Access Compliance Report

(Curb Ramps)

Intersection ID: 6526	Main Street: CENTURY_OAKS_LN	Cross Street: MINERAL_SPRINGS_RD	Location: NE
ADA ID: E3D5910567F9	Ramp Type: PerpDiag	Initial Pass/Fail: Fail	Overall Compliance: No
Severity Score: 21.25			
Codes/Mitigation Info/Possible Solution		Field Measurements/Component Compliance

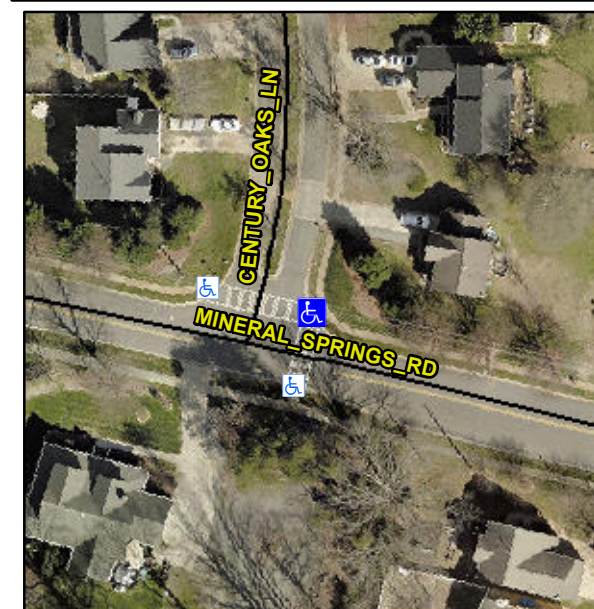
Not Found, R304.5.1, R304.5.3

Compliance	Description	Data	Compliance	Description	Data
N/A	Ramp Length (in)	48.0	Yes	Ramp Slope (%)	7.3
No	Ramp Width (in)	43.0	No	Ramp XSlope (%)	5.6
N/A	Flare Type LT	N/A	N/A	Flare Type RT	N/A
N/A	Flare Slope LT (%)	N/A	N/A	Flare Slope RT (%)	N/A
N/A	Flare Traversable LT?	N/A	N/A	Flare Traversable RT?	N/A
N/A	Landing Length (in)	N/A	N/A	DWS Provided?	N/A
N/A	Landing Width (in)	N/A	N/A	DWS Contrast?	N/A
N/A	Landing Slope (%)	N/A	N/A	DWS Length (in)	N/A
N/A	Landing X Slope (%)	N/A	N/A	DWS Full Width?	N/A
N/A	Landing Curb? (Y/N)	N/A	N/A	DWS Offset (in)	N/A
N/A	Shared Landing?	N/A			
N/A	Gutter Ponding?	N/A	N/A	Gutter Slope (%)	N/A
N/A	Gutter Lip Ht (in)	N/A	N/A	Gutter X Slope (%)	N/A
N/A	Painted X Walk1?	Yes	N/A	Painted X Walk2?	Yes
	X Walk 1 Direction	To W		X Walk 2 Direction	To S
N/A	X Walk 1 Width (in)	112.5	N/A	X Walk 2 Width (in)	112.5
	X Walk 1 Slope (%)	0.6		X Walk 2 Slope (%)	6.1
	X Walk 1 X Slope (%)	5.3		X Walk 2 X Slope (%)	1.4

Remove & Replace Curb Ramp With Two New Directional Ramps or Equivalent.
